DEVIATION REQUEST AND DECISION FORM

Channel Access Spacing

Project Name : Sterling Ranch Sand Creek Channel Construction Drawing Review CDR 20-4
 Schedule No.(s) : 5227301021, 5233309027, 5228000030 & 38, 5233301001 5233301016 & 17
 Legal Description : See Exhibit B – Legal Description

A deviation from the standards of or in Section **ECM section 3.3.3 Open Channel Design Standards** of the Engineering Criteria Manual (ECM) is requested for the Sand Creek Channel Design – Channel Access Spacing.

CHANNEL ACCESS EXHIBIT
 SAND CREEK RESTORATION
 JOB NO. 25188.04
 10/19/23
 SHEET 1 OF 1

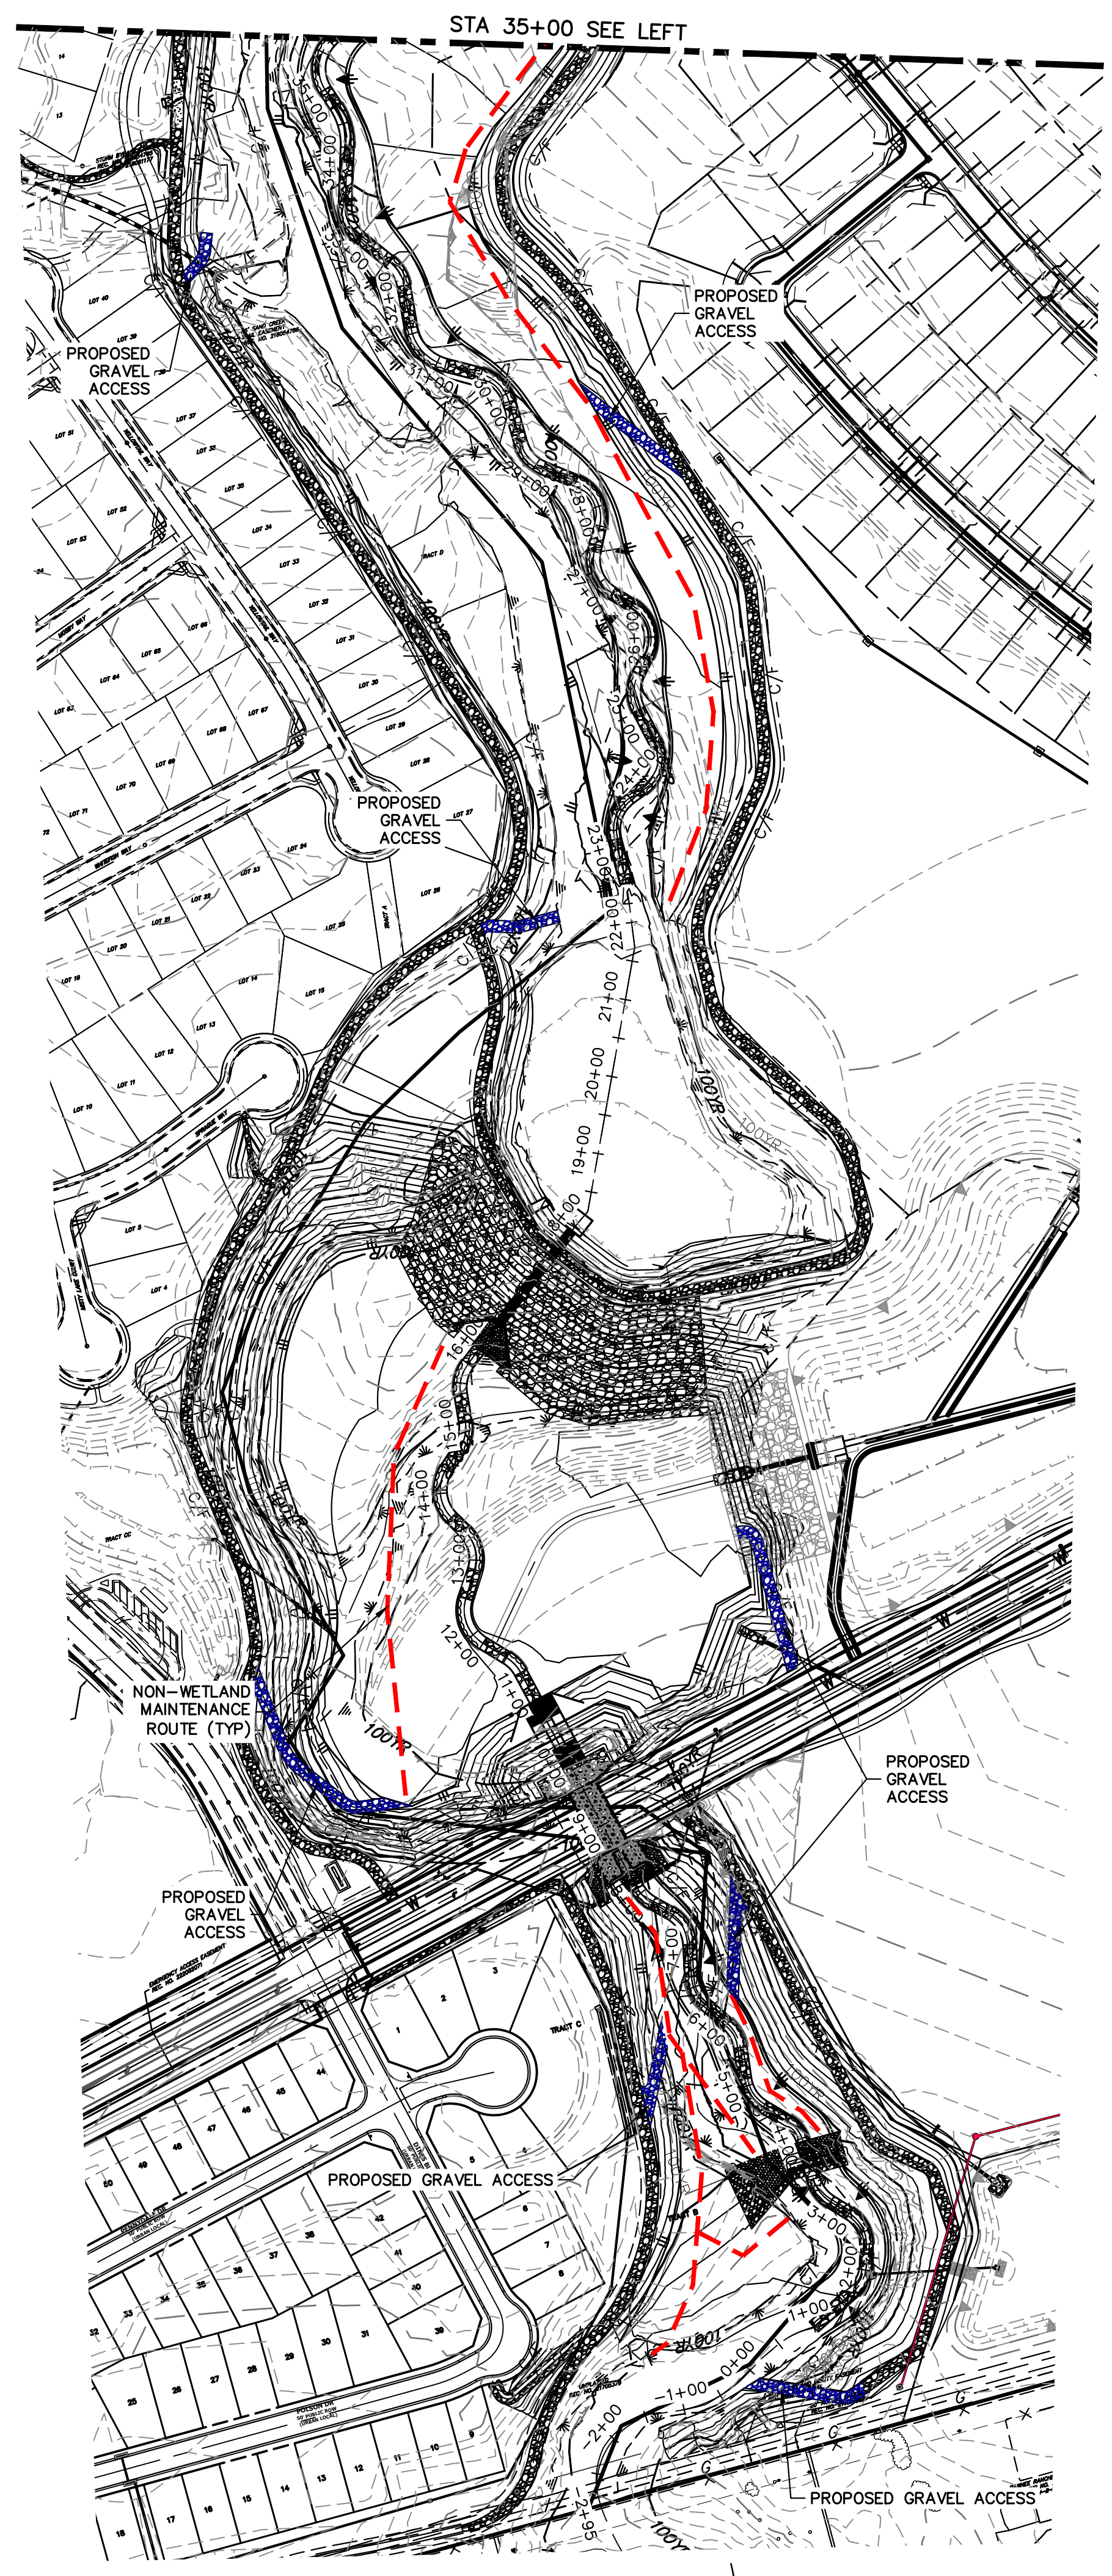
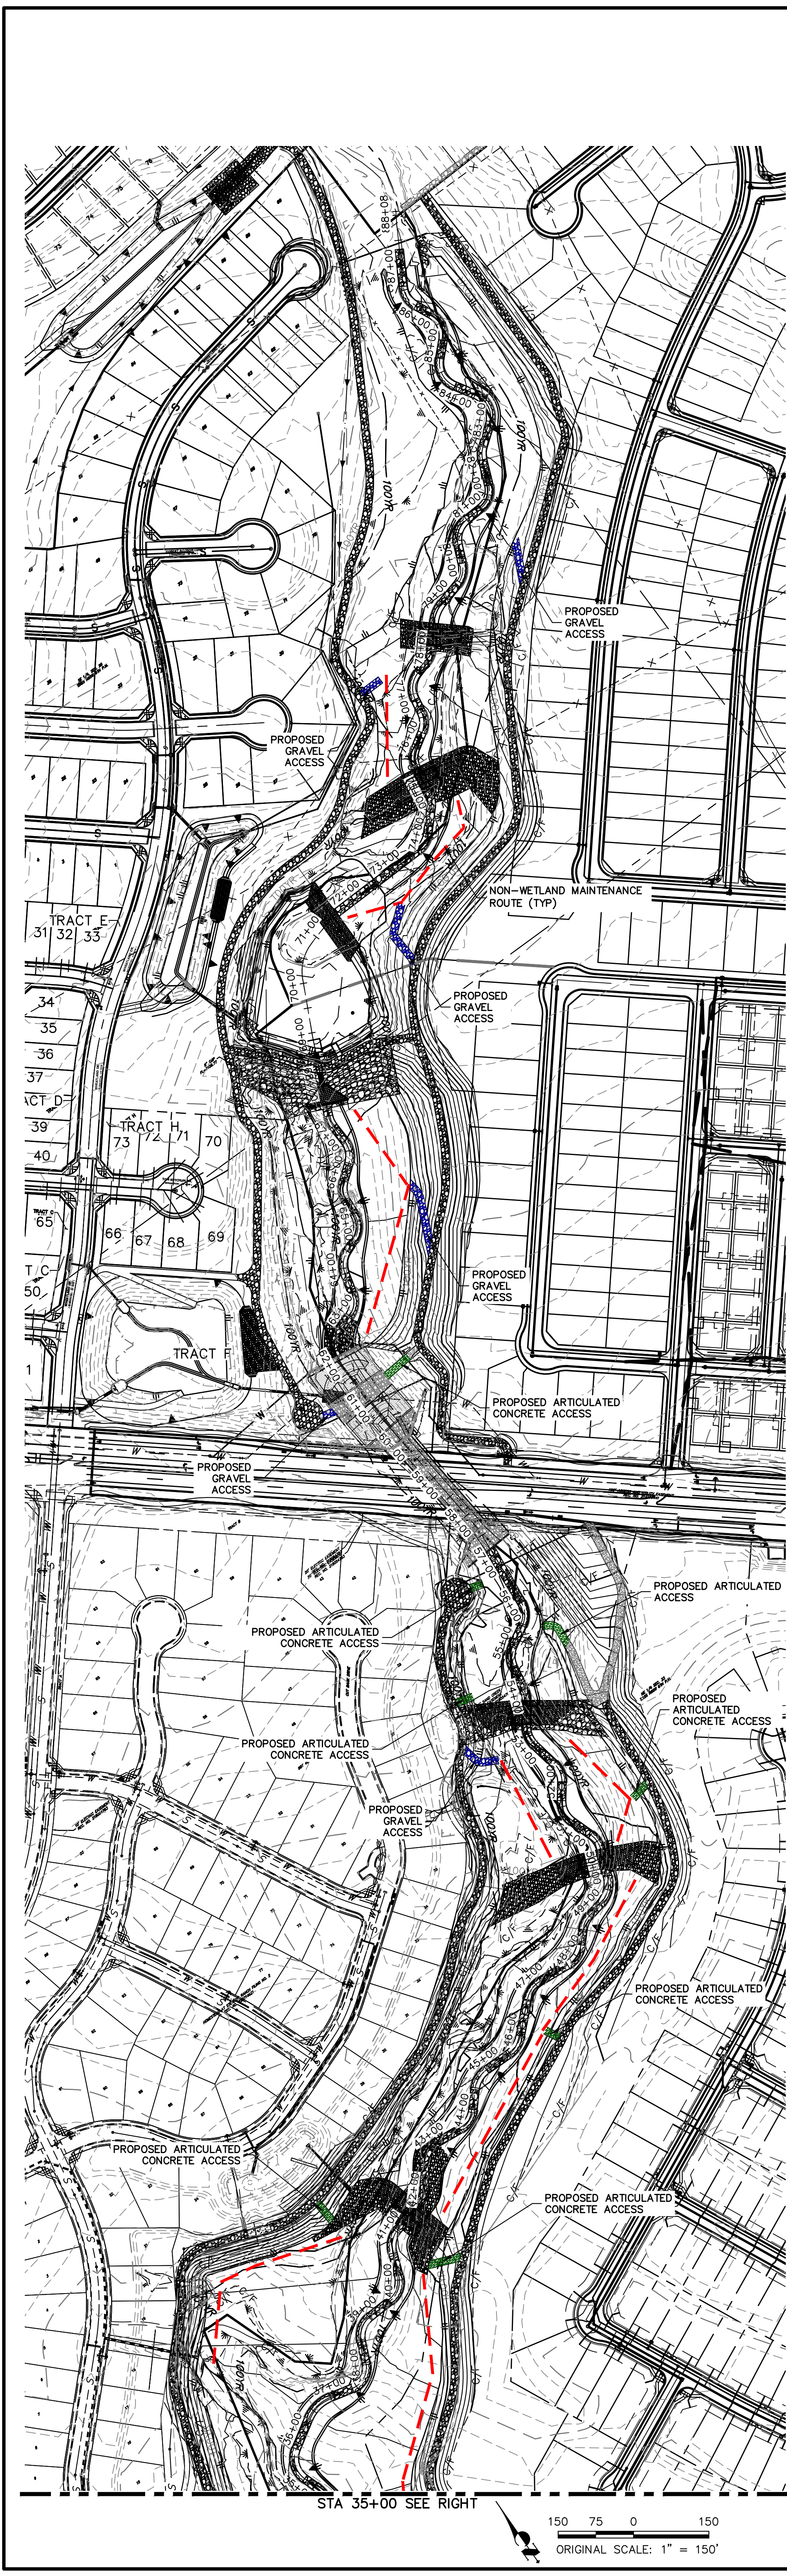
The Sand Creek Channel design has a minimum spacing of 300 feet and maximum spacing of 1,200 feet between access ramps to the bottom of the channel.

A more "natural" channel design is being proposed for this reach within Sterling Ranch and there are only 8 drop structures, two roadway crossings, one inline flood control detention pond and two existing stock ponds in the 9,000 feet of channel being improved. Access ramps to the bottom of the channel are provided near each structure listed above.

In total, there are 24 total access ramps to the bottom of the channel as shown in table in Exhibit A.

To place a channel bottom access ramp every 500 feet is not feasible as it would add to the disturbance of the existing wetland as well as reduce the area available for wetland mitigation. Because of the natural channel design concept being proposed, maintenance activities requiring larger equipment are reduced and are focused around the 8 drop structures, 2 stock ponds, inline Pond W-3 and the plate arch culverts for Briargate Parkway and Sterling Ranch Road.

This request has been determined to have met the criteria for approval. A deviation from Section 3.3.3, Item K.1. of the ECM is hereby granted based on the justification provided.
